# GRID CODE REVIEW PANEL

## HV DC INTERCONNECTORS WORKING GROUP REPORT TO THE GRID CODE REVIEW PANEL

## Appendix 4 - Proposed Grid Code Modifications

GCRP 02/31  
**Figure CC.A.3.1 - Minimum Frequency Response Requirement Profile**  
 for a 0.5 Hz frequency change from Target Frequency

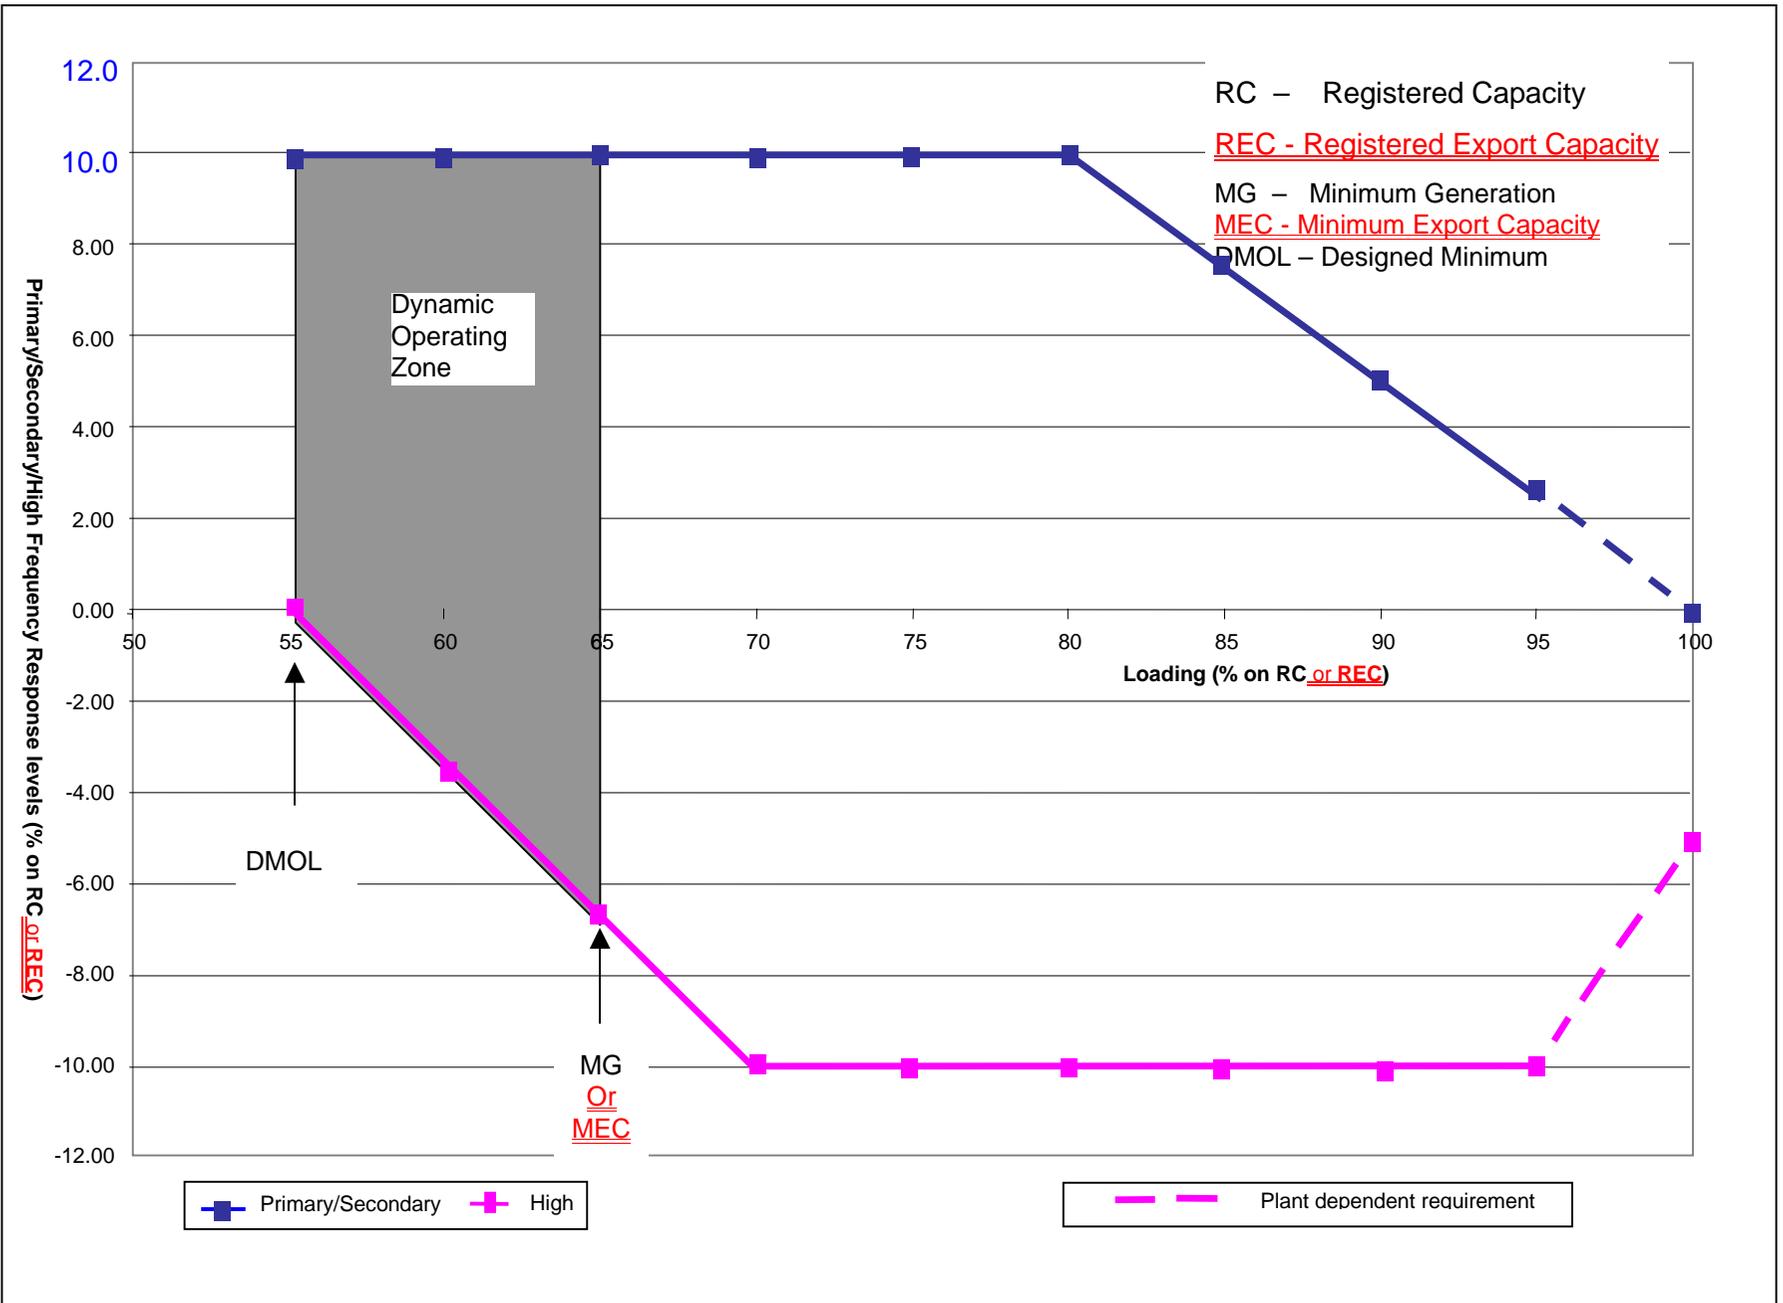
Each **Generating Unit** ~~and/or~~ **CCGT Module** or DC Converter Station must be capable of providing some response, in keeping with its specific operational characteristics, when operating between 95% to 100% of **Registered Capacity** (or Registered Export Capacity) as illustrated by the dotted lines in Figure CC.A.3.1.

At the **Minimum Generation** level, each **Generating Unit** and/or **CCGT Module** is required to provide high and low frequency response depending on the **System Frequency** conditions. At the Minimum Export Capacity level, each DC Converter Station is required to be capable of providing high and low frequency response depending on the System Frequency conditions. Where the **Frequency** is high, the **Active Power** output is therefore expected to fall below the **Minimum Generation** (or Minimum Export Capacity) level.

The **Designed Minimum Operating Level** is the output at which a **Generating Unit** ~~and/or~~ **CCGT Module** or DC Converter Station has no **High Frequency Response** capability. It may be less than, but must not be more than, 55% of the **Registered Capacity** (or Registered Export Capacity). This implies that a **Generating Unit** ~~or~~ **CCGT Module** or DC Converter Station is not obliged to reduce its output to below this level unless the **Frequency** is at or above 50.5 Hz (cf BC3.7).

Figure CC.A.3.2 - Interpretation of Primary and Secondary Response Values

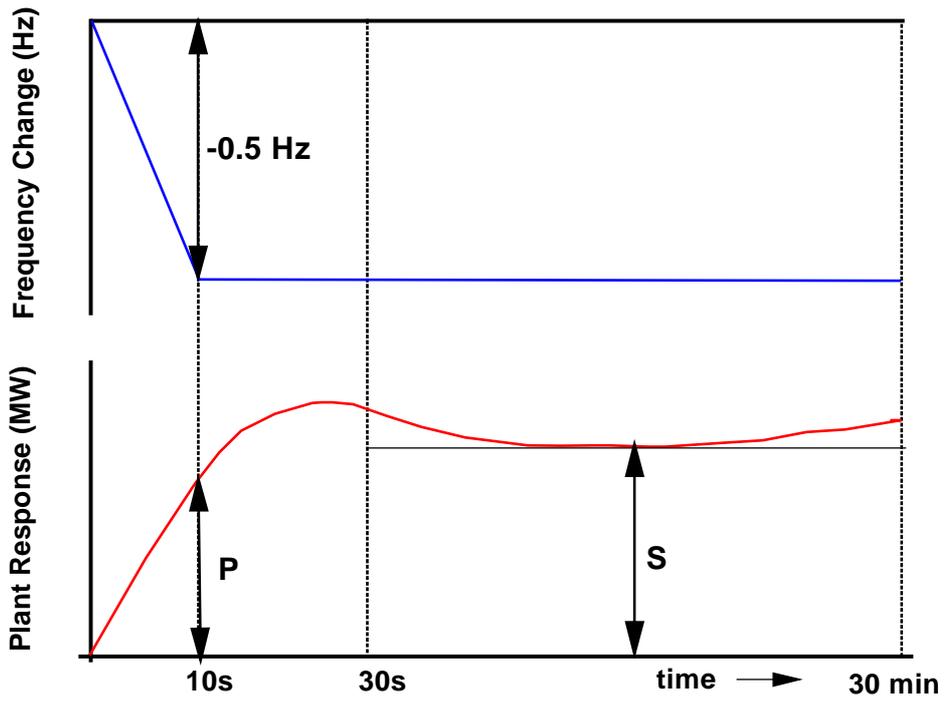
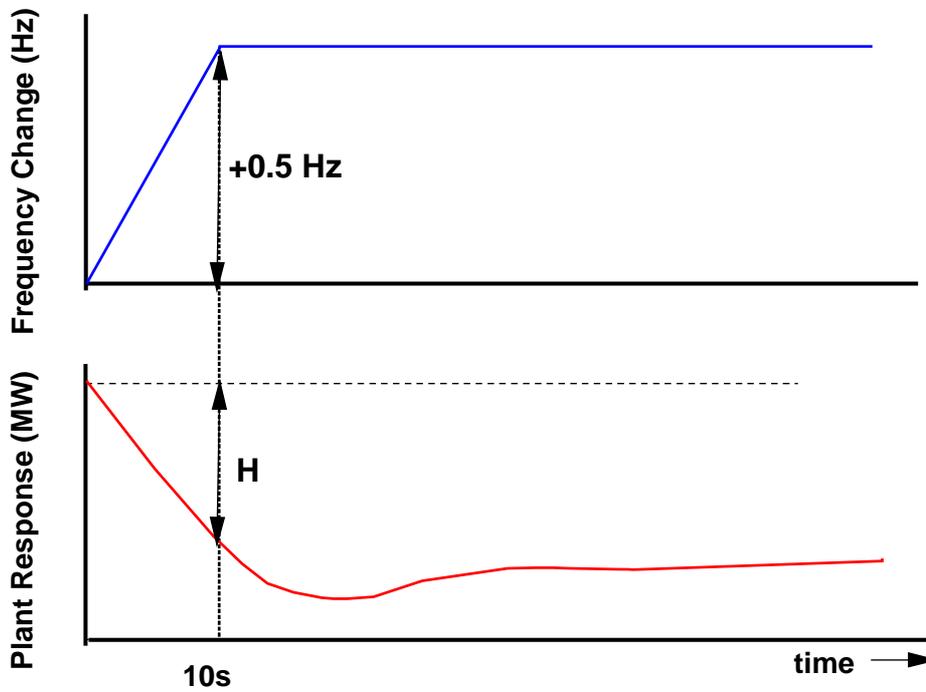
The **Primary Response** capability (P) of a **Generating Unit~~-or-a~~, CCGT Module or DC Converter Station** is the minimum increase in **Active Power** output between 10 and 30 seconds after the start of the ramp injection as illustrated diagrammatically in Figure CC.A.3.2.

The **Secondary Response** capability (S) of a **Generating Unit~~-or-a~~, CCGT Module or DC Converter Station** is the minimum increase in **Active Power** output between 30 seconds and 30 minutes after the start of the ramp injection as illustrated diagrammatically in Figure CC.A.3.2.

The **High Frequency Response** capability (H) of a **Generating Unit~~-or-a~~, CCGT Module or DC Converter Station** is the decrease in **Active Power** output provided 10 seconds after the start of the ramp injection and sustained thereafter as illustrated diagrammatically in Figure CC.A.3.3.
